**ADDENDUM NO. 1**  
**TENDER NO. 138-24**  
**DERWENT PARK CRICKET FIELD**

**January 15, 2025**

# CONTRACT DRAWINGS FOR DERWENT PARK CRICKET FIELD CITY OF WINDSOR

project no. 22-040  
drawing no. 22-040-03  
sheet no. 3 of 7  
scale AS SHOWN

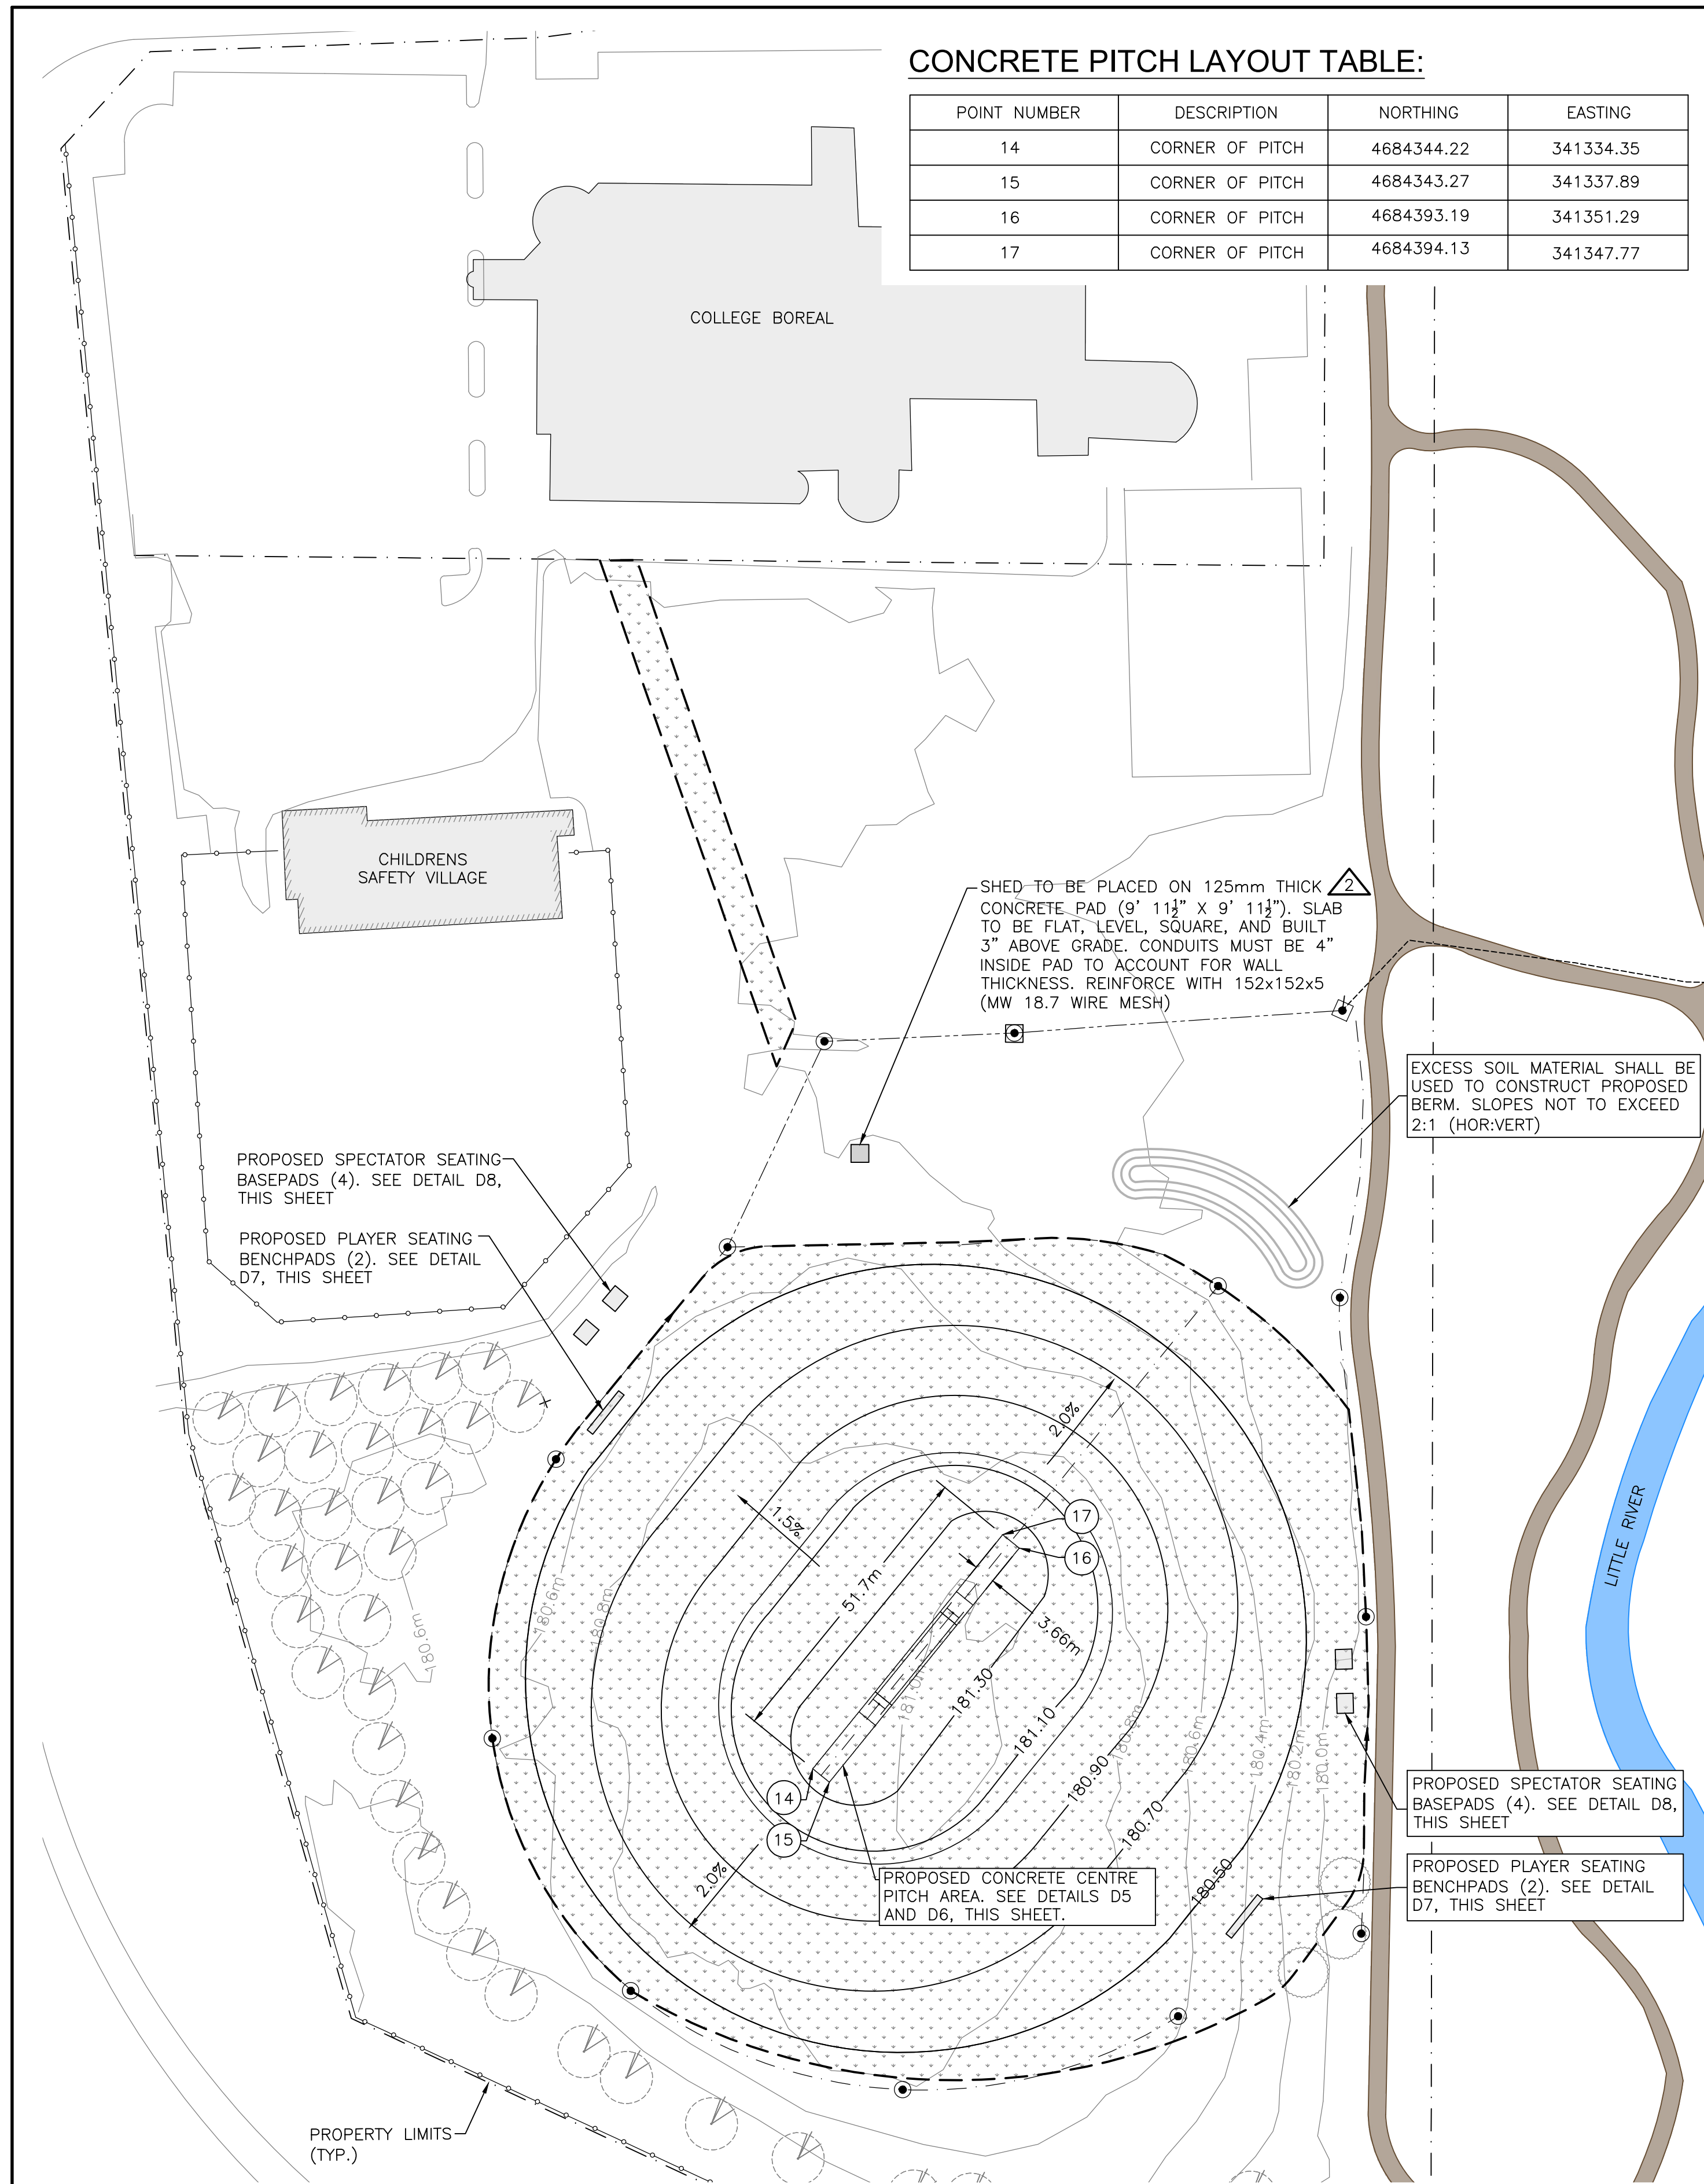
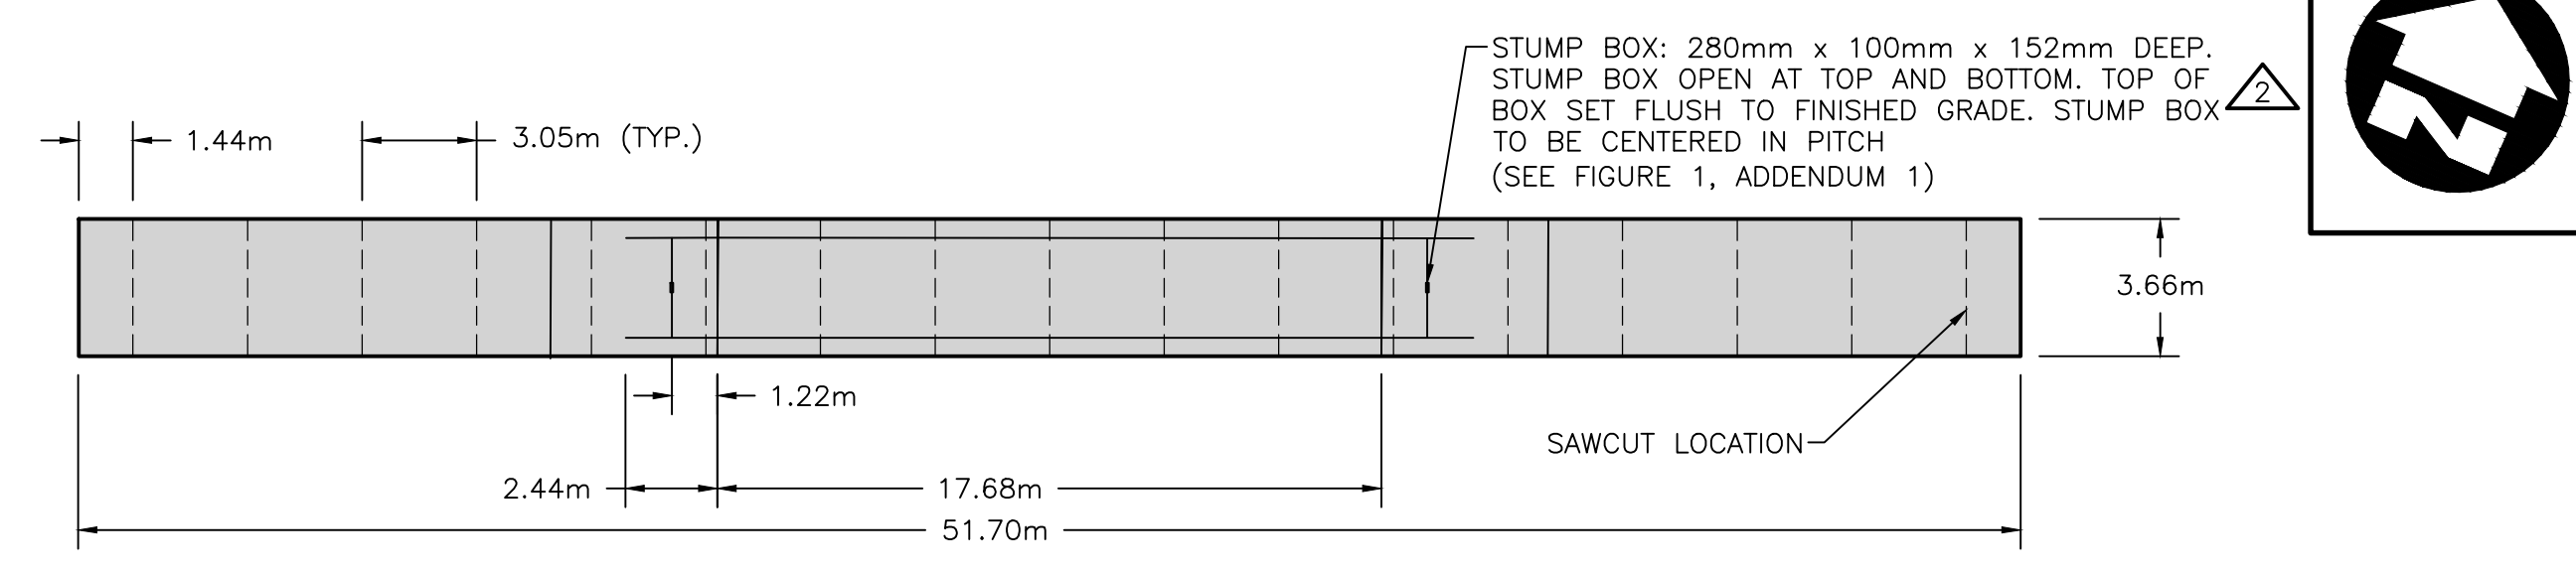
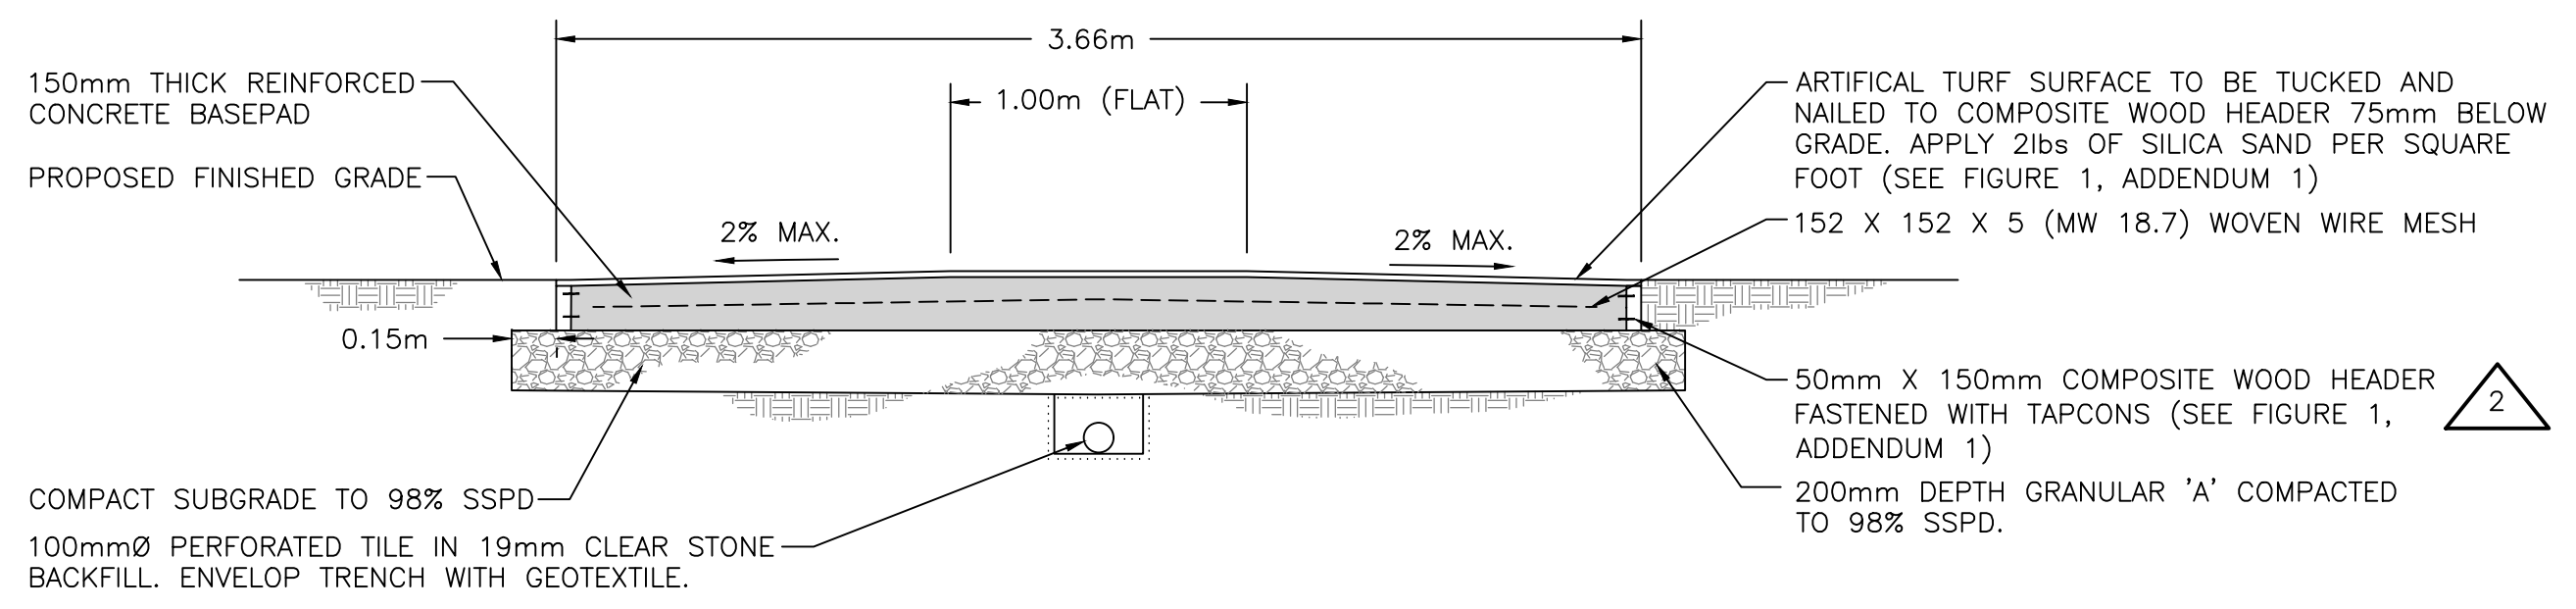
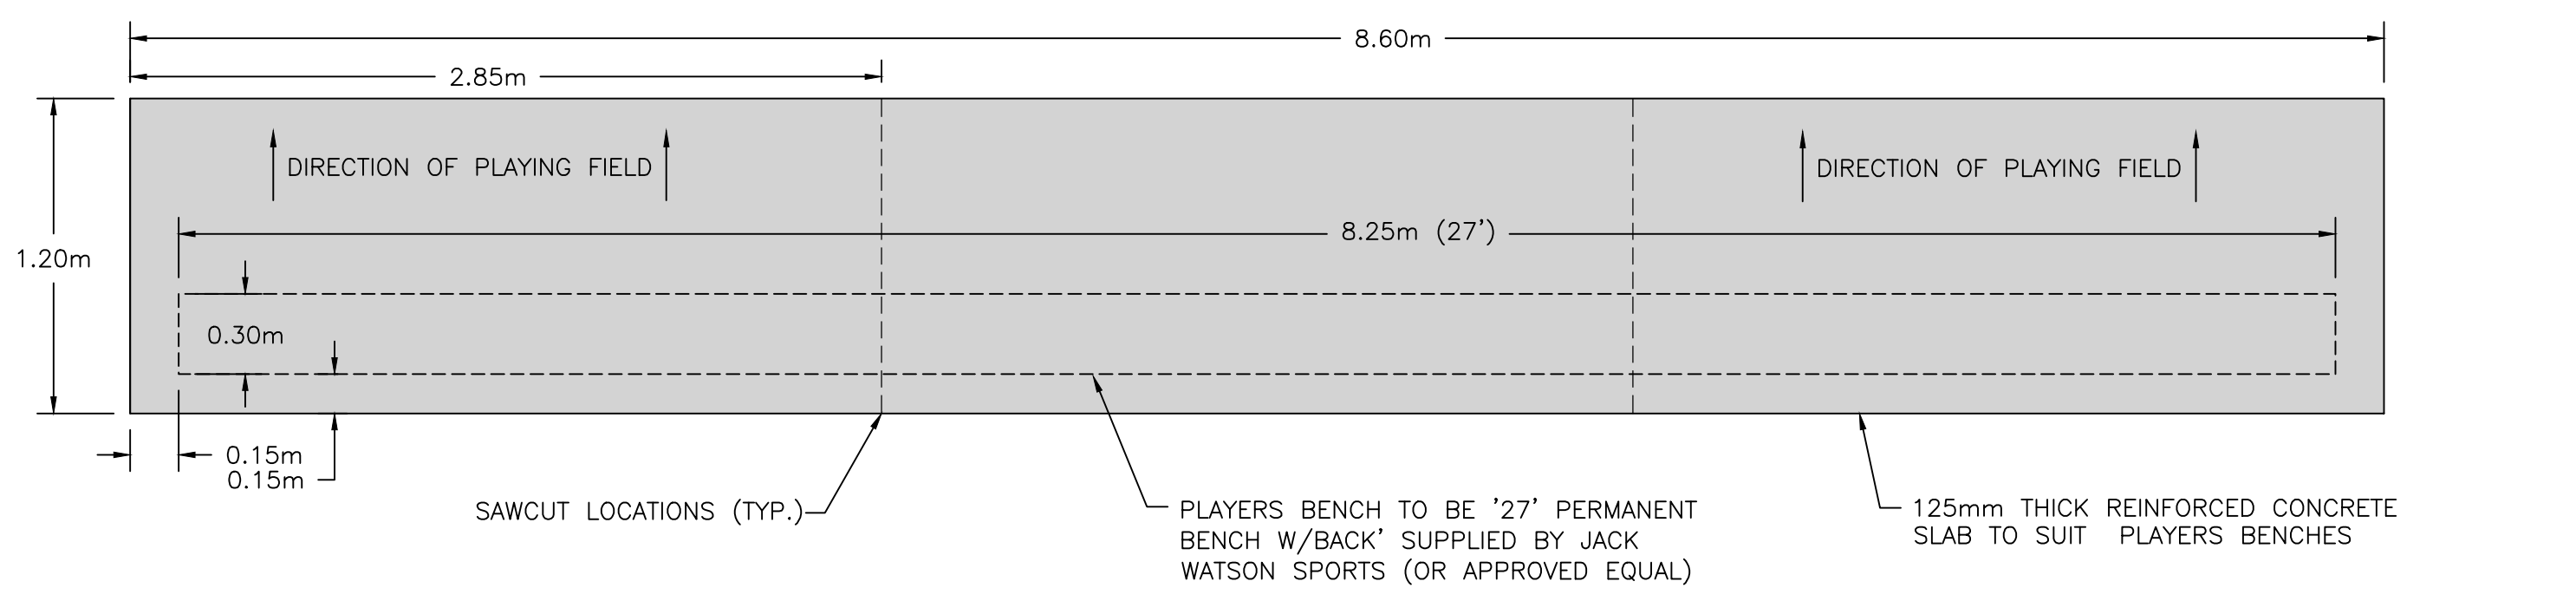
**8. Does the EuroShed get constructed on a concrete base?**

The EuroShed shall be constructed on a concrete base. The details for the concrete pad have been amended and are depicted on sheet 22-040-03
